HISTORIC AND DESIGN REVIEW COMMISSION

HDRC CASE NO: 2022-577
ADDRESS: 305 LAVACA ST
LEGAL DESCRIPTION: NCB 708 BLK 8 LOT 2 ***MASTER FILE-COMMON ELEMENTS*** (305 LAVACA TOWNHOUSES)
ZONING: RM-4, H
CITY COUNCIL DIST.: 1
DISTRICT: Lavaca Historic District
APPLICANT: Tim Rodgers/South Flores Construction
OWNER: Tony Pearson/305 LAVACA TOWNHOUSES
TYPE OF WORK: New construction of two 2-story, single-family structures and one 2-story duplex structure
APPLICATION RECEIVED: March 17, 2023
60-DAY REVIEW: Not applicable due to City Council Emergency Orders
CASE MANAGER: Rachel Rettaliata
REQUEST:

The applicant is requesting conceptual approval to construct two 2-story, single-family structures and one 2-story duplex structure at 305 Lavaca.

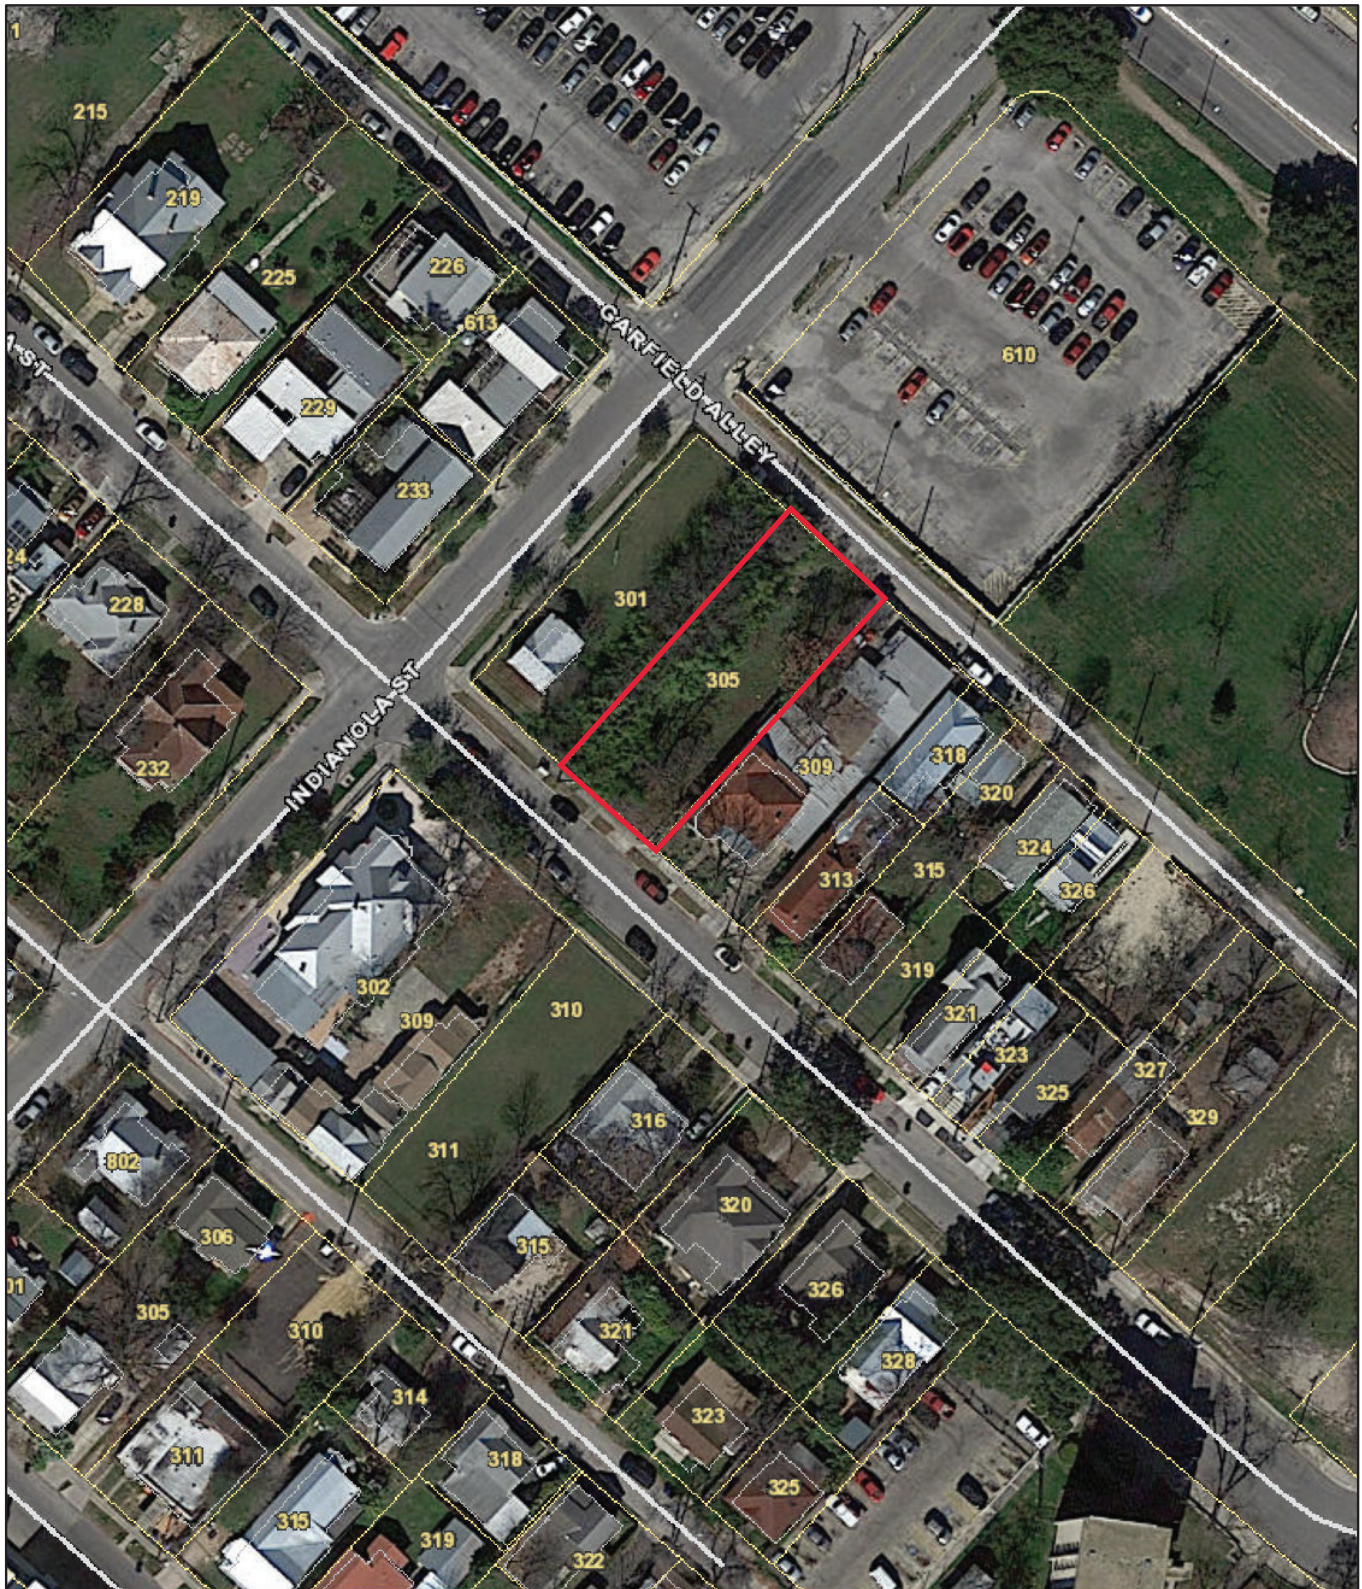
- dd. **LANDSCAPING PLAN** – The applicant has proposed to install plantings at the front of each structure and along the west property line. Staff finds that the applicant should install landscape elements that are consistent with those found historically in the district and should submit a comprehensive landscaping plan to staff for review.

- viii. That the front walkways match the front walkway materials found historically within in the district based on finding bb.
- ix. That the applicant installs landscape elements that are consistent with those found historically in the district and submits an updated landscaping plan to staff for review prior to returning to the HDRC based on finding dd.

④ SIDE ELEVATION- WEST

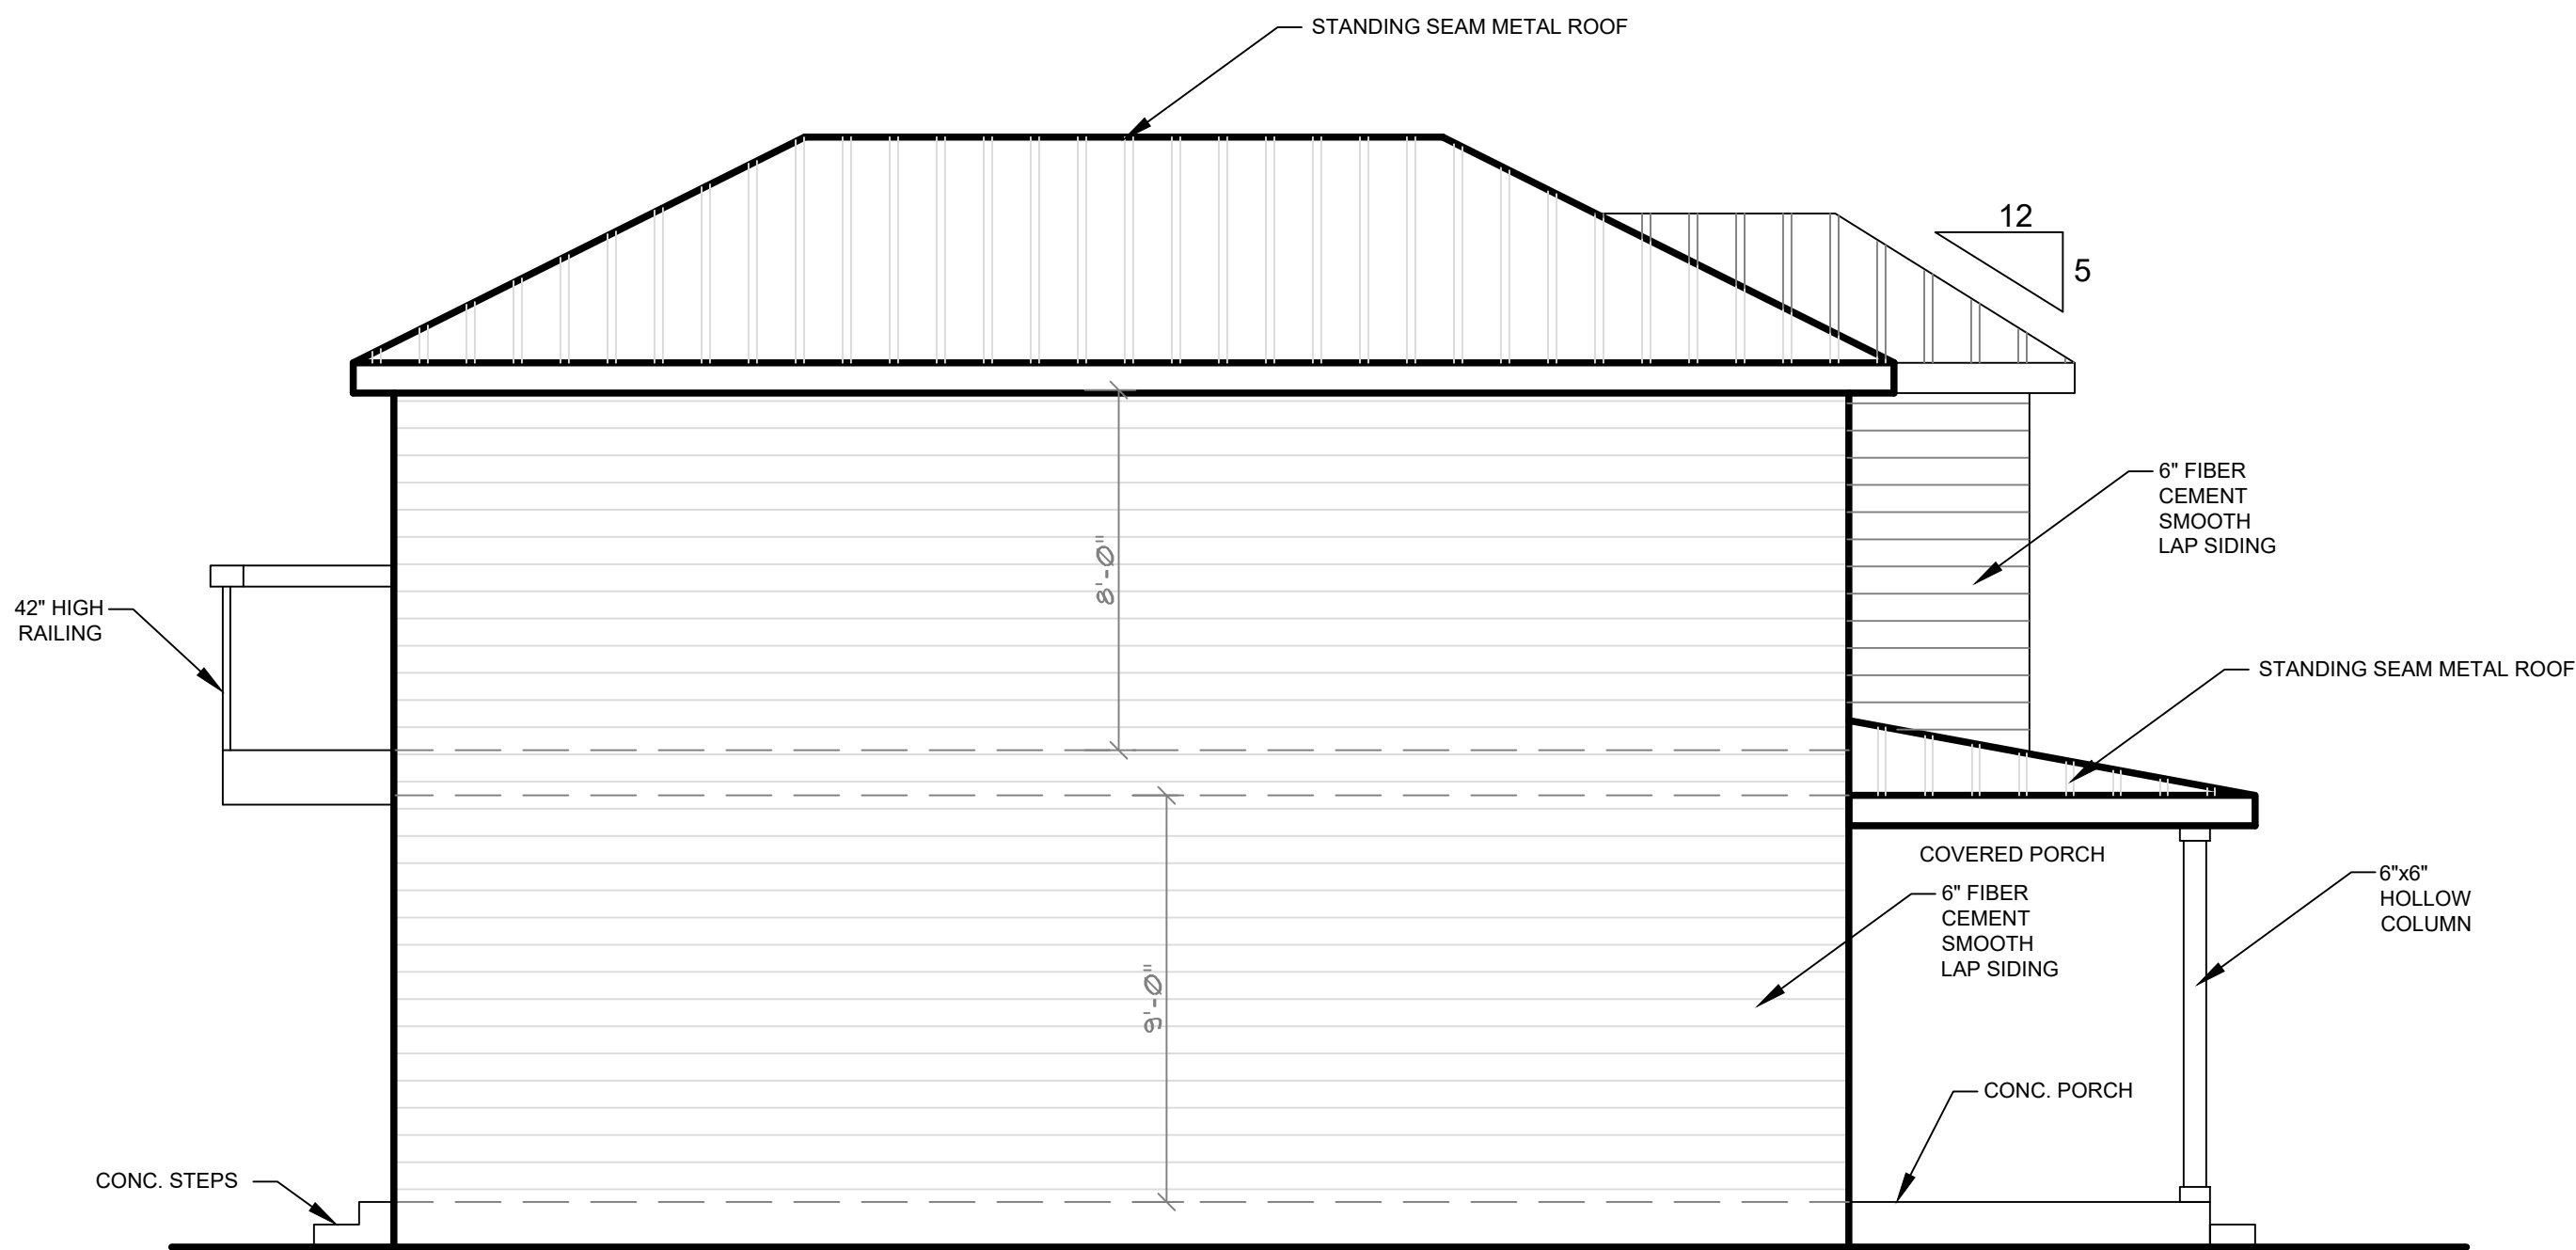
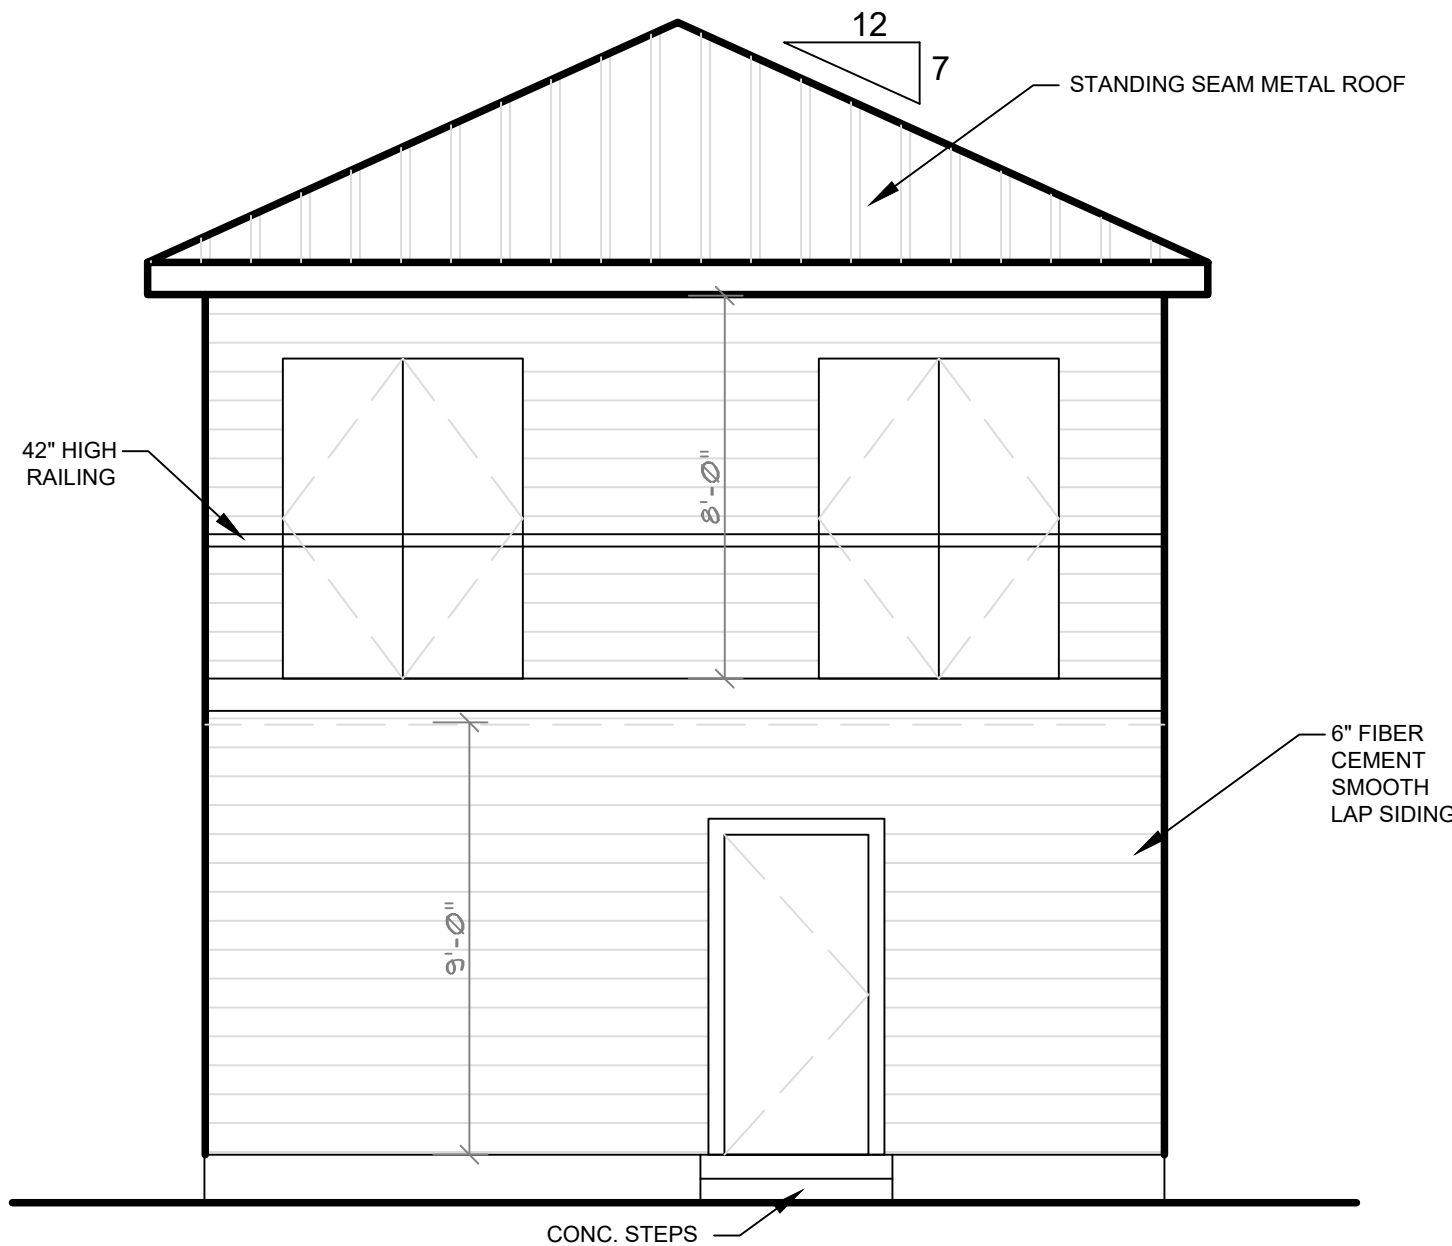
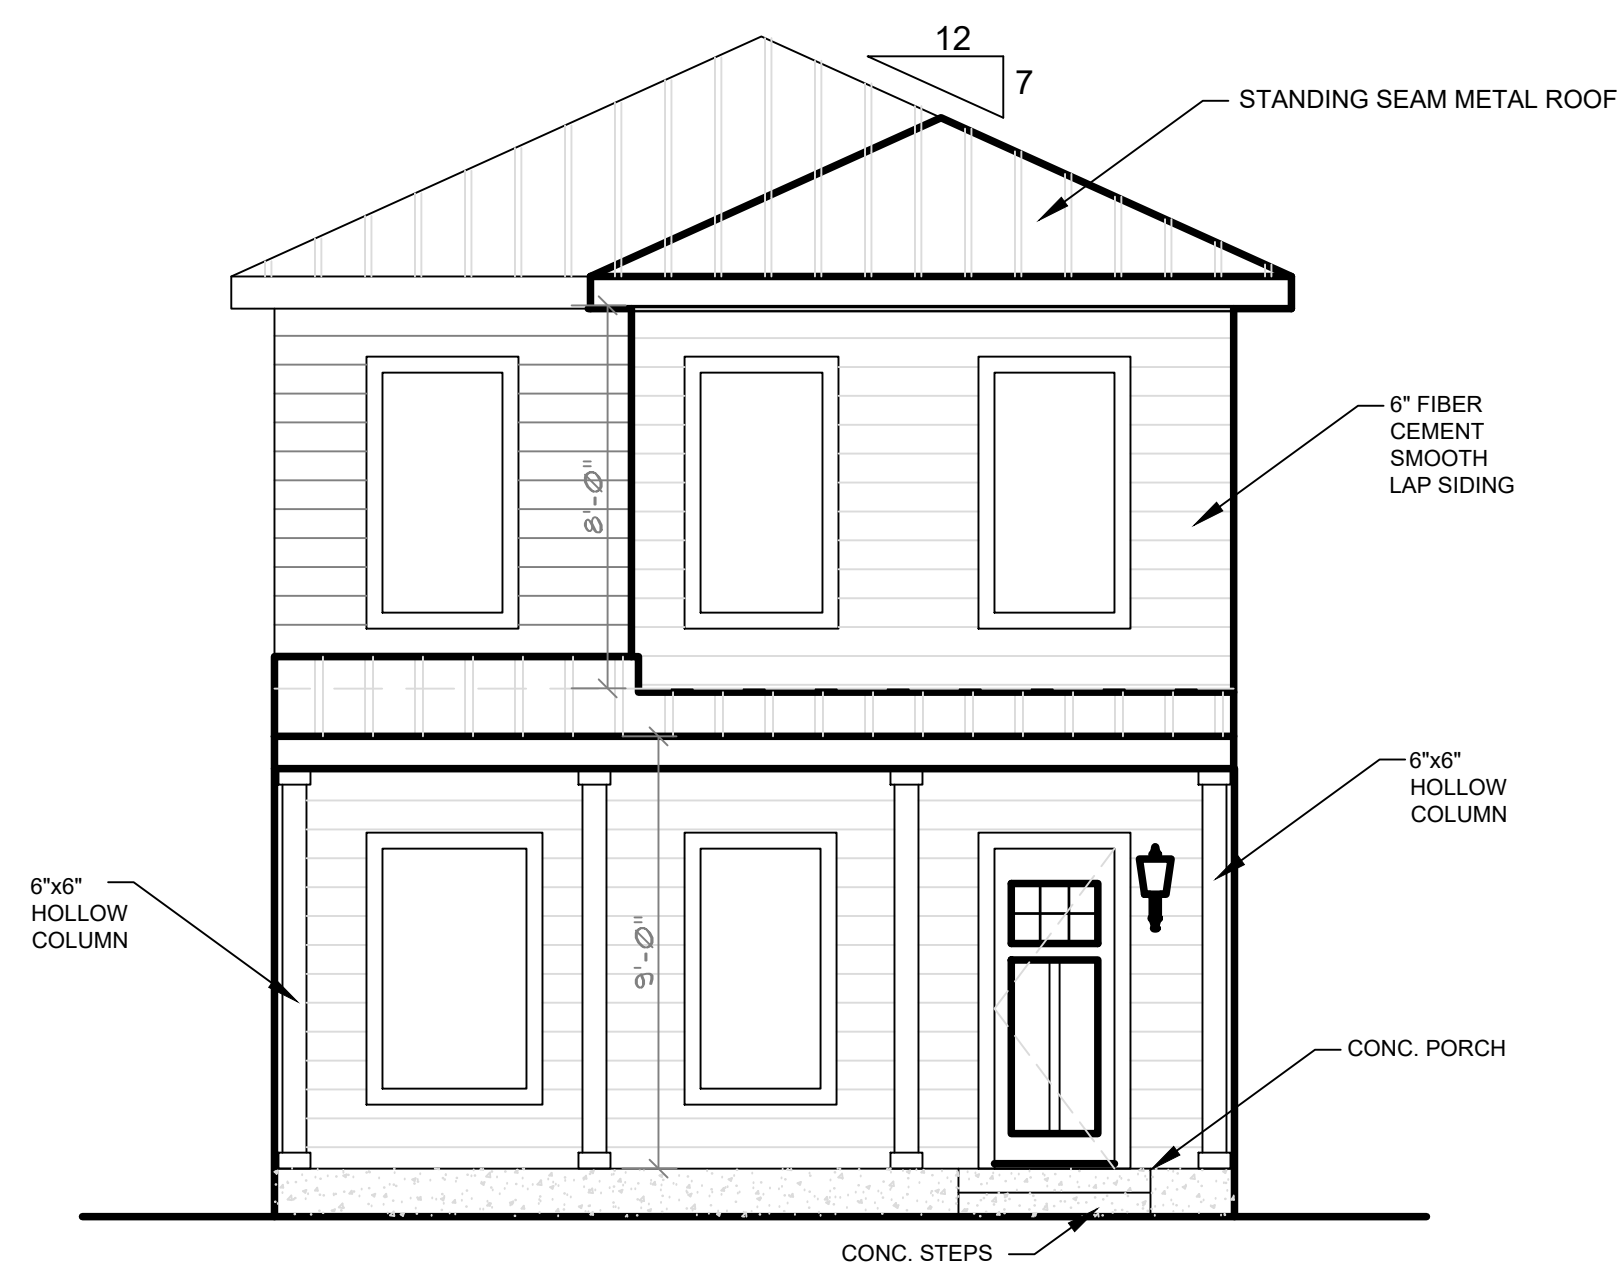
JF: I think the infill development that you provide will help to provide context. On Unit 2, I would recommend looking into more fenestration on the outside facing elevation. Staff can help you with window details regarding true vs faux divided lites etc.
